# UNITED STATES PATENT AND TRADEMARK OFFICE

APPLICATION NO.	FILING DATE	FIRST NAMED INVENTOR	ATTORNEY DOCKET NO.	CONFIRMATION NO.
10/693,529	10/24/2003	Robert Johnston	RIVER-001XX	2299
28452	7590	01/25/2006	EXAMINER	
BOURQUE & ASSOCIATES, P.A. 835 HANOVER STREET SUITE 303 MANCHESTER, NH 03104			LARSON, JUSTIN MATTHEW	
			ART UNIT	PAPER NUMBER
			3727

<b>Office Action Summary</b>	<b>Application No.</b>	<b>Applicant(s)</b>	
	10/693,529	JOHNSTON ET AL.	
	<b>Examiner</b>	<b>Art Unit</b>	
	Justin M. Larson	3727

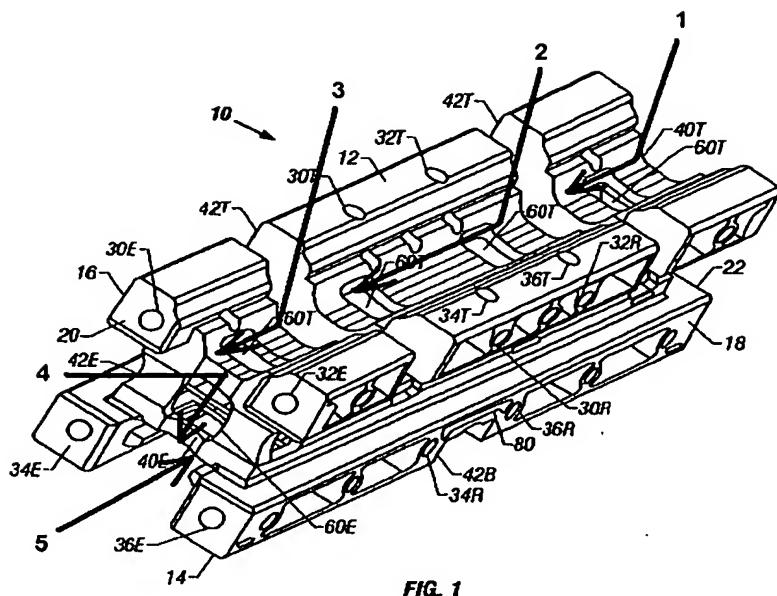
Regarding claim 1, Szigeti discloses a carrier comprising a body of resilient material, said body including: a bottom surface and a top surface, the top surface including a plurality of raised protrusions defining a support surface, said plurality of protrusions also defining a first and at least second support channel (1 & 2, respectively, below) disposed substantially transverse to said support surface.

Regarding claims 2, the carrier of Szigeti further has a third and at least a fourth support channel (3 & 4, respectively, above) on a first and at least second side of the body.

Regarding claim 3, the third and fourth support channels of Szigeti are aligned with the first and second support channels.

Regarding claim 4, the carrier of Szigeti has a fifth support channel disposed along the bottom surface, the channel being aligned with the third and fourth support channels.
